Re: Matakanui Gold Limited Fast Track Approvals Application – Lighting RFI

Request for Further Information: Lighting

Following receipt of the Lighting / Dark Sky Joint Witness Statement (JWS) dated 26 May 2026, at the direction of the Panel, the EPA has requested the following information. My responses are included below.

Figure 2 Working Lights on a PC3400 Excavator

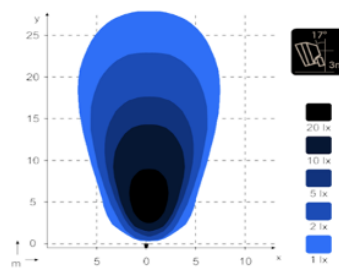
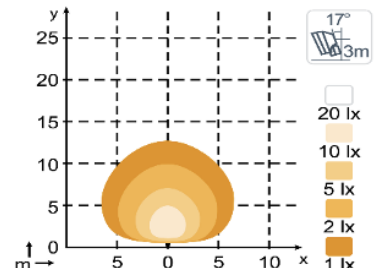
1. *If possible, quantify and provide an expert assessment of the magnitude of additional impacts from illumination levels, beyond those already identified, that are likely to result from moving and static vehicle lighting (including headlights and any required hazard awareness flashing lights, for example) during all phases of the proposal. It is expected that such an assessment would need to determine (as accurately at possible) the variety of different vehicle types and specifications which are likely to be utilised on the site during the hours of darkness.*

- c) Work lights on machinery will vary by machine type, make and model. I have assessed the work lights on a PC3400 excavator which consists of the lighting configuration shown in Figure 2. According to the data supplied by Komatsu, the total luminaire lumens is 75,600 lumens per excavator. A single luminaire generating 4,200 lumens will result in an illuminance of 1 lux at 25m from the luminaire when mounted at a height of 3m and a downward tilt of 17.

Figure 3 Position of cross -section A-B through ELF

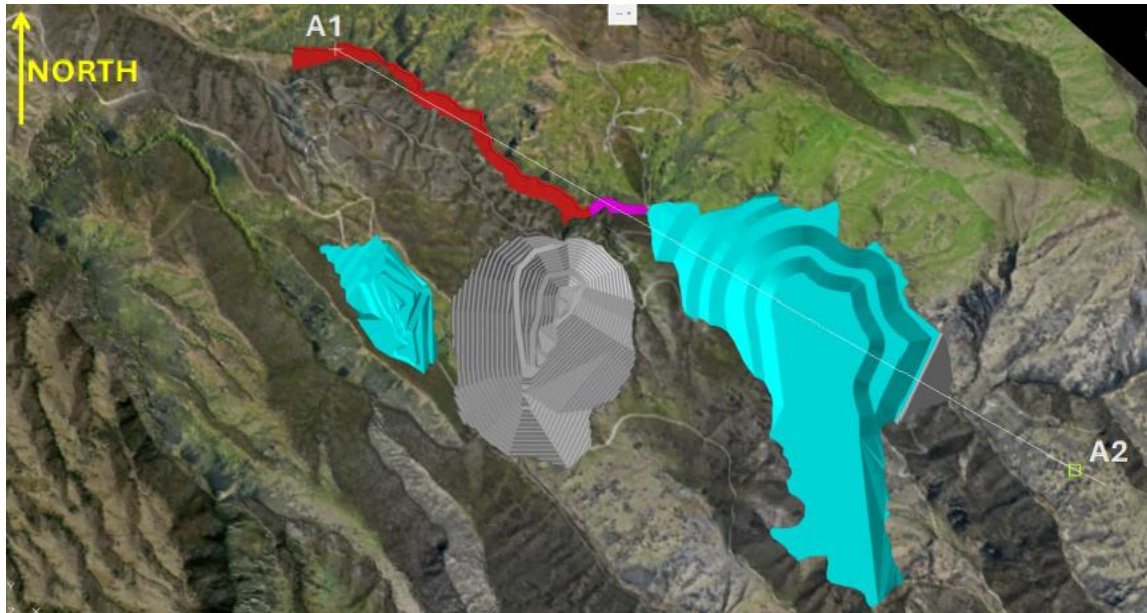
2. Outline specific proposed mitigation measures (such as physical barriers, as suggested at paragraph [41] of the JWS) to address any identified additional impacts from vehicle lighting.

- b) We understand that MGL will endeavour to minimise the effects of vehicle lighting at night through design and staging of ELF construction and we recommend a condition requiring that. As far as reasonably practical the outer edges will be raised during the hours of daylight to a higher elevation than the inner area. The inner area will be used during the night hours, with vehicle lights shielded to the extent practical by the elevated edges. Figures 3 and 4 show how vehicle driving and working lights may be screened behind a working bund.
